KANSAS GAS AND ELECTRIC COMPANY

KMLNRC 81-082

Re: Docket Number STN 50-482

The referenced letter requested additional information concerning the Wolf Creek Generating Station, Unit No. 1 Environmental Report - Operating License Stage. Transmitted herewith are responses to questions in the referenced letter. The remaining outstanding responses will be forwarded to you in August, 1981. This information will be formally incorporated into the Wolf Creek Generating Station Unit No. 1 Environmental Report - Operating License Stage in Revision 2. This information is hereby incorporated into the Wolf Creek Generating Station Operating License Application.

Q 240.8
FIGURE
FLOW-DURATION CURVE -
DAILY FLOW OF NEOSHO RIVER
AT BURLINGTON

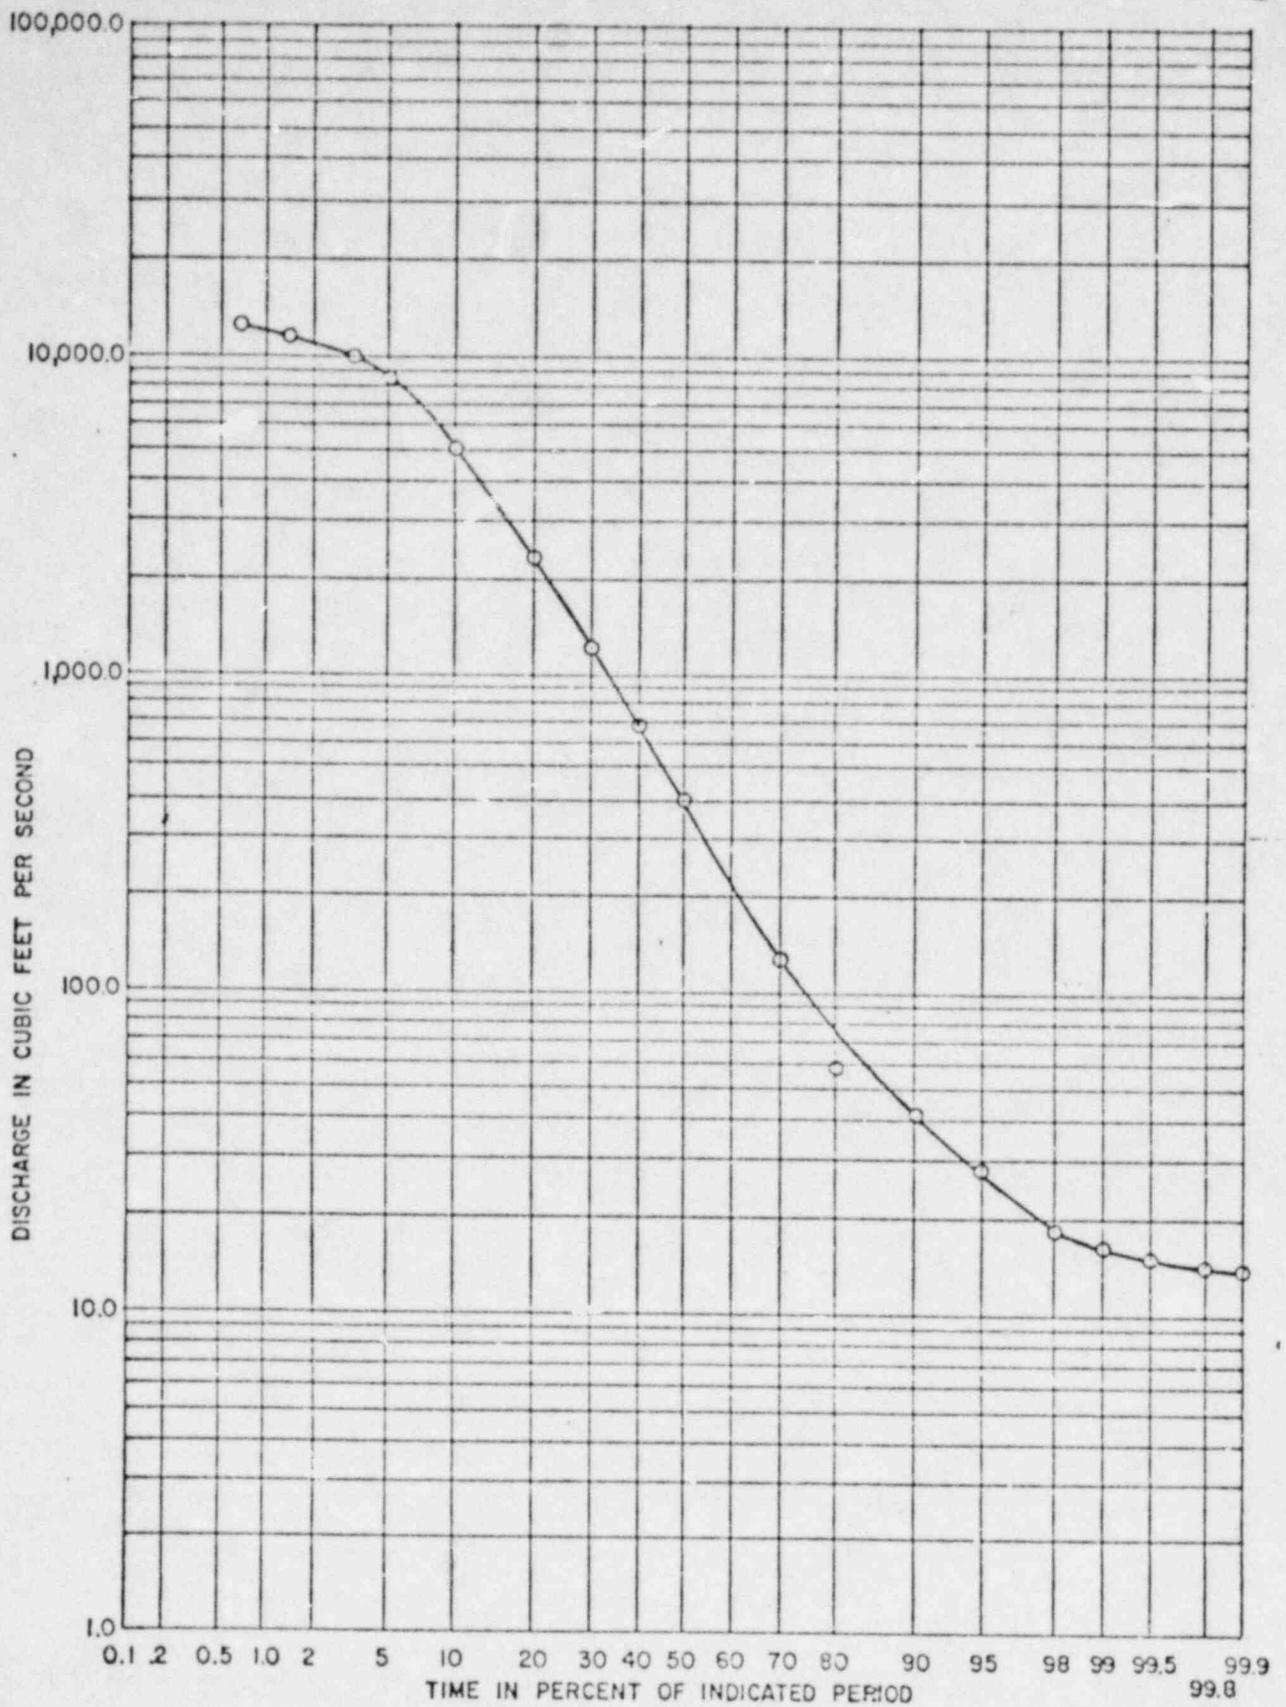
Provide a flow-duration curve for the Neosho River at Wolf Creek reflecting regulation by the John Redmond Reservoir. Also, provide an estimate of the 7 consecutive day once in 10 year low flow for the river at Wolf Creek under the same conditions. Discuss the effect of plant operation on these parameters. Provide in your discussion your assumptions regarding reservoir release rates and plant withdrawals used in your analysis.

The nearest U.S. Geological Survey gaging station on the Neosho River downstream of John Redmond Reservoir and near the confluence of Neosho River and Wolf Creek is at Burlington, Kansas. This gaging station at Burlington, Kansas, is approximately five miles downstream of John Redmond Reservoir and the confluence of Neosho River and Wolf Creek is approximately 4 miles downstream of this gaging station. The flow-duration information for Neosho River at Burlington, Kansas, for the period October 1964 to September 1979 is presented in Figure 1. The 7-day 10-year low flow for the same period is 17.3 cfs.

During low flows, the flows in Neosho River below John Redmond Reservoir would constitute the releases from the reservoir for water rights and water quality purposes. Even with plant operation at WCGS, the releases for water rights and water quality will be made from the Reservoir and, hence, the flow-duration for the low-flow range would not be affected at Burlington nor at Wolf Creek.

TDS LIMITED BLOWDOWN
 Figure 1
 Q 291.2

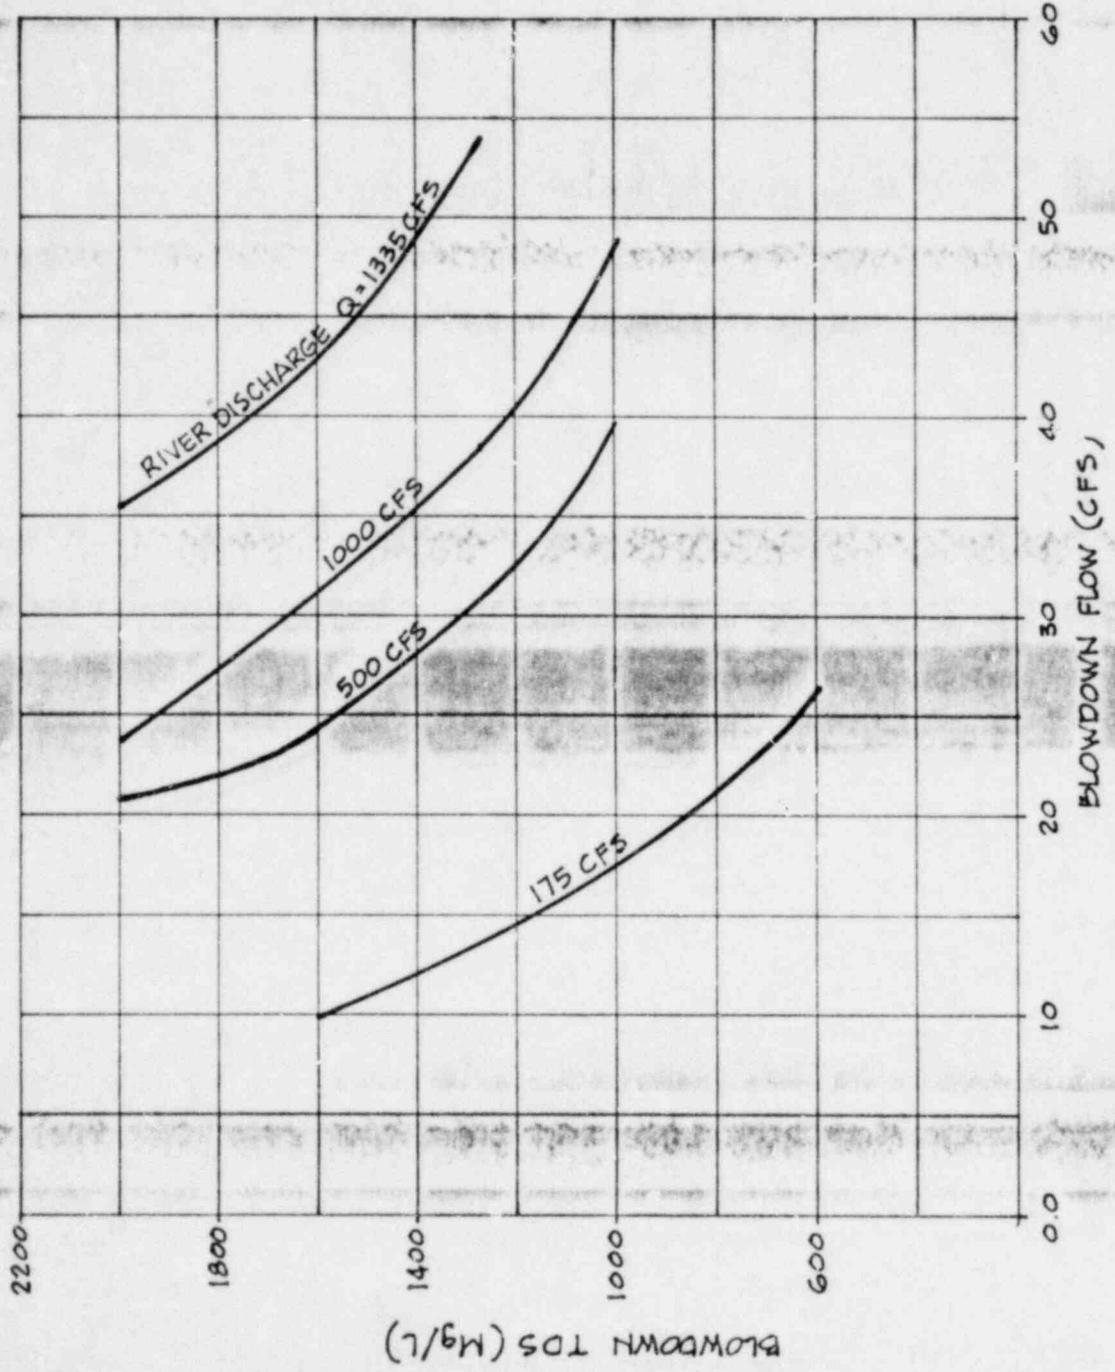
- (a) Provide a complete description of the model used to calculate the allowable blowdown limits;
- (b) Indicate the values used for the diffusion parameters and flow velocities in these calculations. Describe the model assumptions made in these calculations;
- (c) The data given in the ER imply that the concentrations of TDS, SO_4^{2-} and Cl^- in the blowdown are the same as those in the cooling lake. However, such factors as incomplete diffusion or mixing of solutes or concentration stratification in the cooling lake might make the blowdown solute concentration different from that of the lake as a whole. Indicate whether such factors have been considered and, if so, what analysis has been made.
- (d) Provide the basis of or the source(s) for the criteria for TDS, SO_4^{2-} and Cl^- cited for the Neosho River.

Different combinations of Neosho River discharge, blowdown discharge and initial effluent TDS concentration are used in the computations. Figure 1 is a summary of the results. The maximum flow area in the cross-section along the length of the river which is having a concentration > 500 mg/l (includes 400 mg/l Neosho River ambient TDS concentration) is computed and plotted against the blowdown discharge with C_0 as a variable. From these curves the blowdown discharges and C_0 values corresponding to the maximum flow area equal to 25% of the total flow cross-section are picked and plotted on Figure 1 with the Neosho River discharge as a variable. The 25% flow area is designated as a mixing zone according to Kansas Water Quality Criteria for interstate and intrastate waters of Kansas.

FIGURE III.1
EVACUATION ROUTES

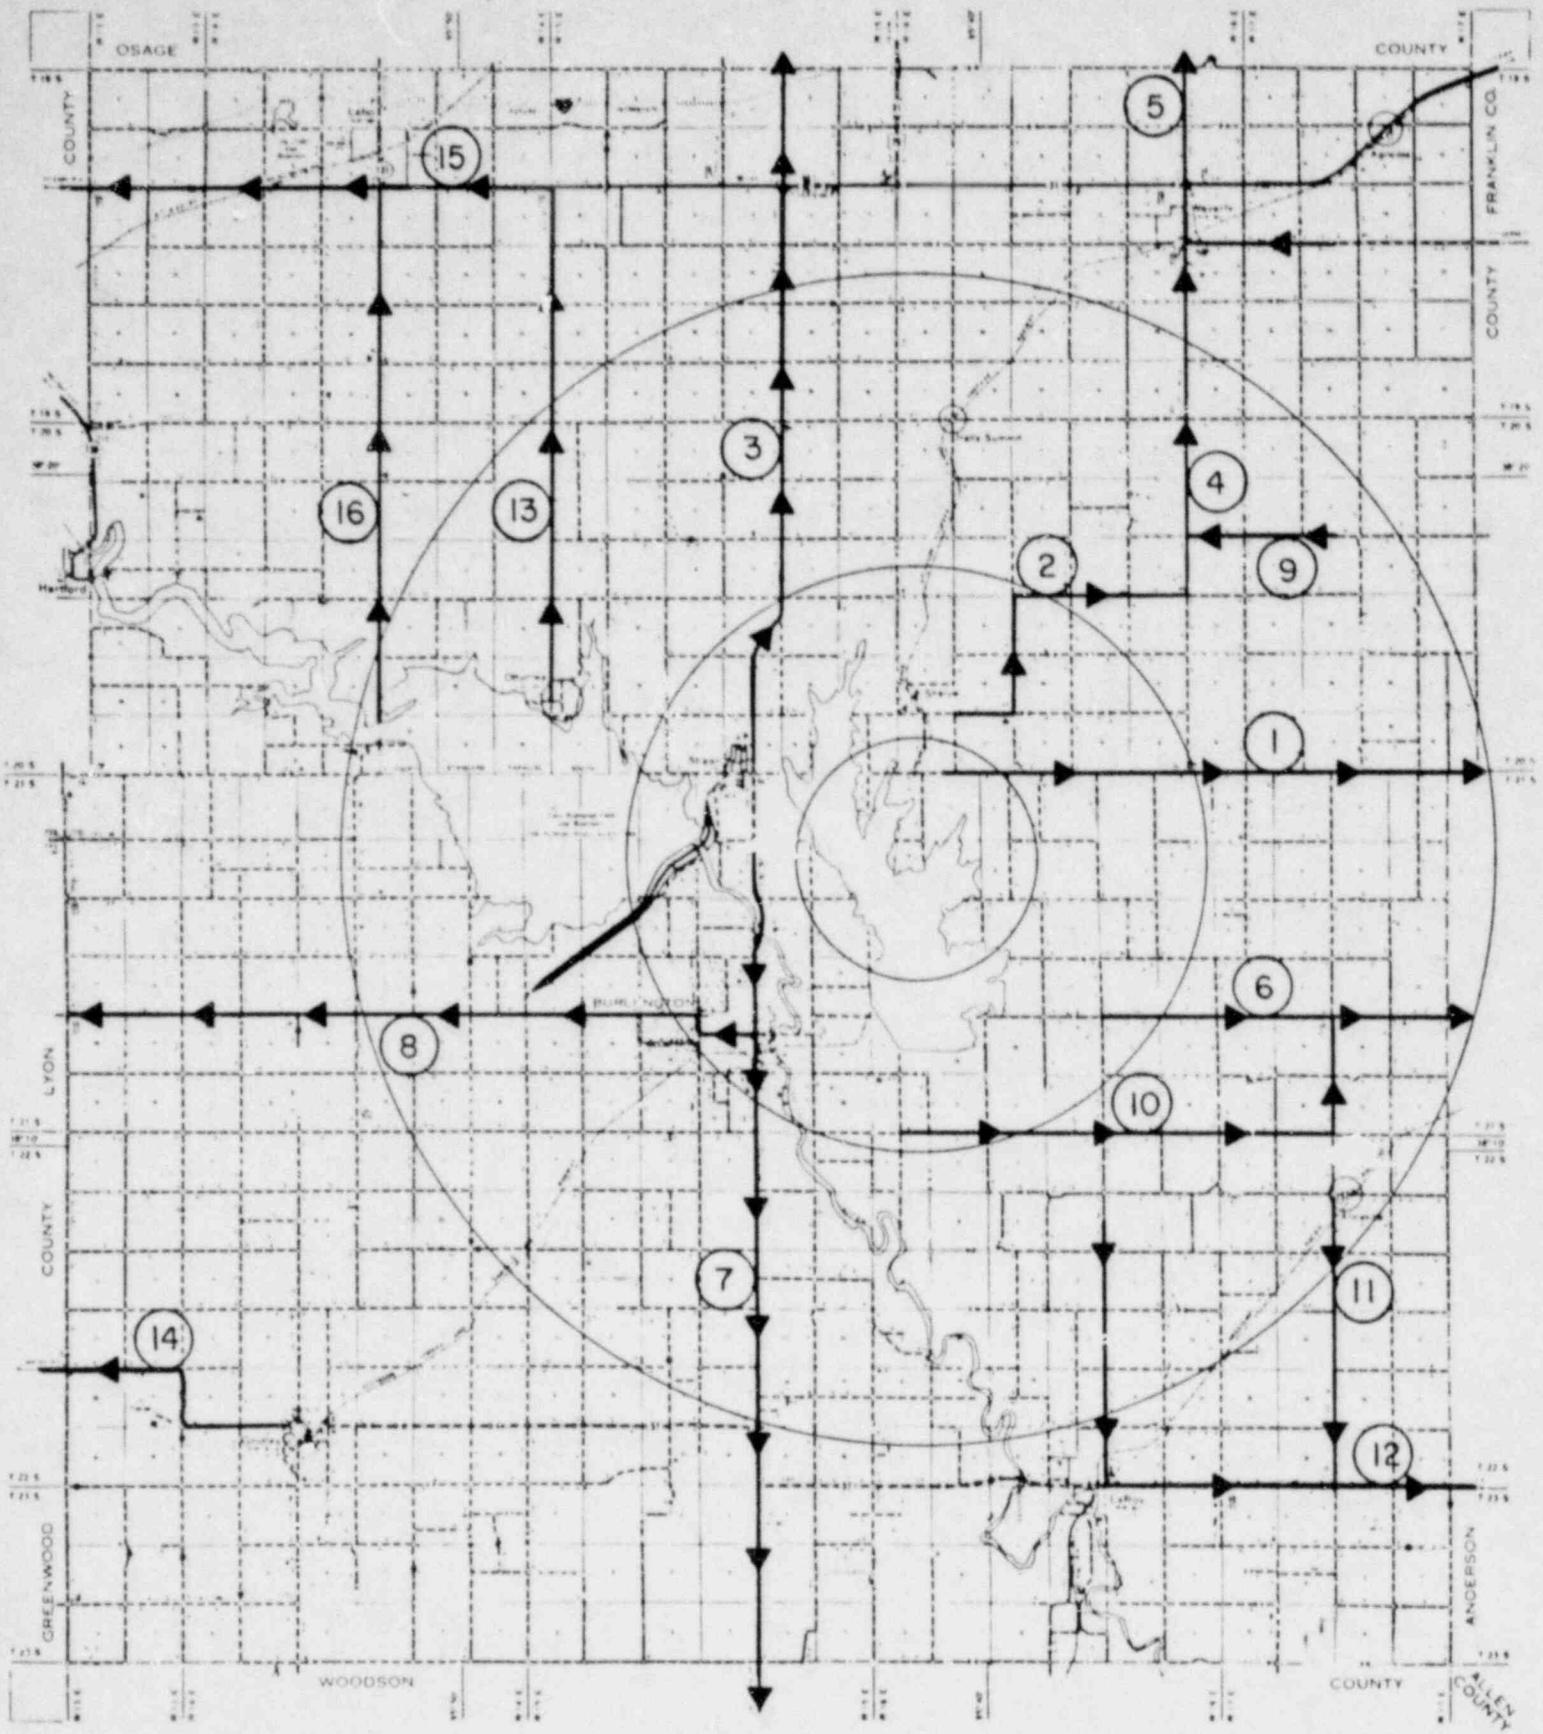
Q450.2 Please provide a transportation map detailing any
(ER) controlled roads, uncontrolled roads, and rail-
roads within two miles of the cooling lake. In
addition, if available, provide data on the extent
of traffic density on the controlled and uncon-
trolled roads.

R450.2 See Figure 450.2-1.

Coffey County has not developed traffic flow data for the roads near the cooling lake. The following data are annual average daily traffic estimates (AADT) made by the Kansas Highway Commission for Highway 75 north of Burlington between the city limit and New Strawn.
